ISSUE DATE: 5-11-12 **PERMIT** P 537804  
APPROVAL DATE: 5/29/12 A \_\_\_\_\_

**ON-SITE SEWAGE DISPOSAL SYSTEM  
TANK REPLACEMENT  
HOWARD COUNTY HEALTH DEPARTMENT  
BUREAU OF ENVIRONMENTAL HEALTH**

ADDRESS: 5472 Harris Farm Lane PROPERTY OWNER: Michael and Jami Jacobs

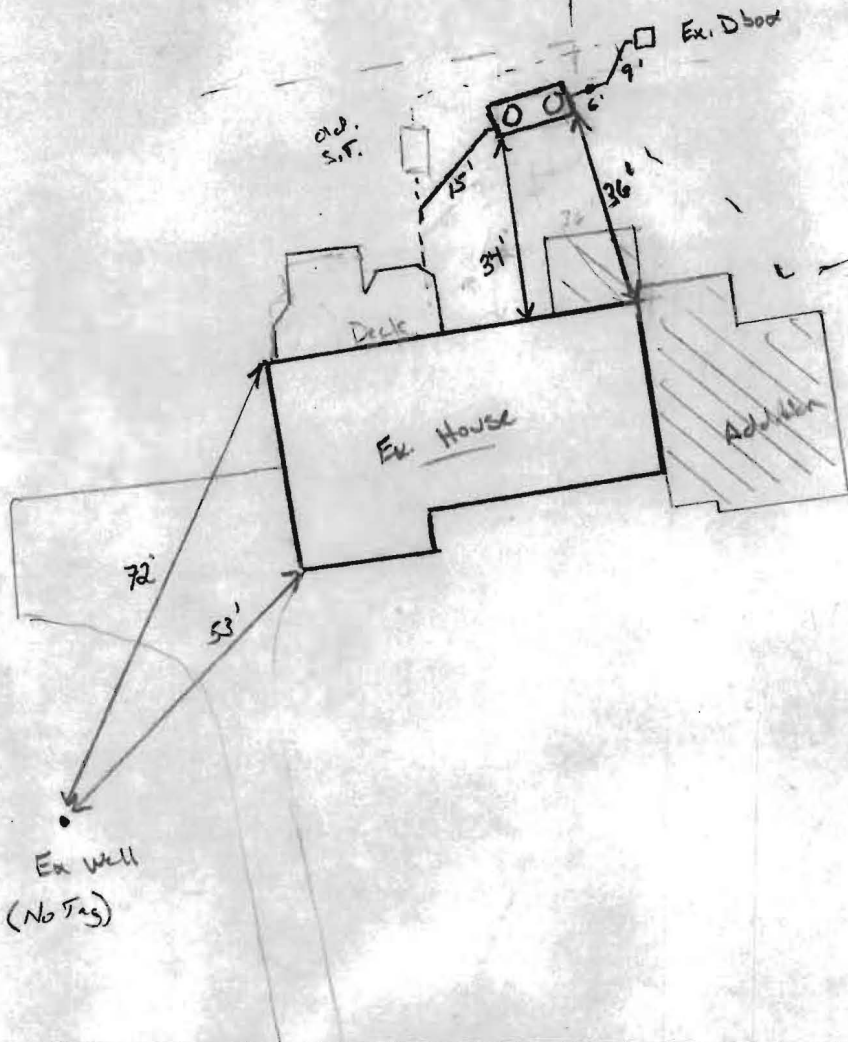
5/21/12 Keep new S.T. 20' from proposed dwelling and addition.  
 Call when tank is installed to inspect. Do not cover  
 and open work (JW)

5/29/12 New S.T. installed 20' from proposed addition's  
 plumbing installed. sch 40 existing already. 4" added between  
 S.T. and Dbox. Dbox not exposed. Ex. S.T. pumped and  
 collapsed. (JW)
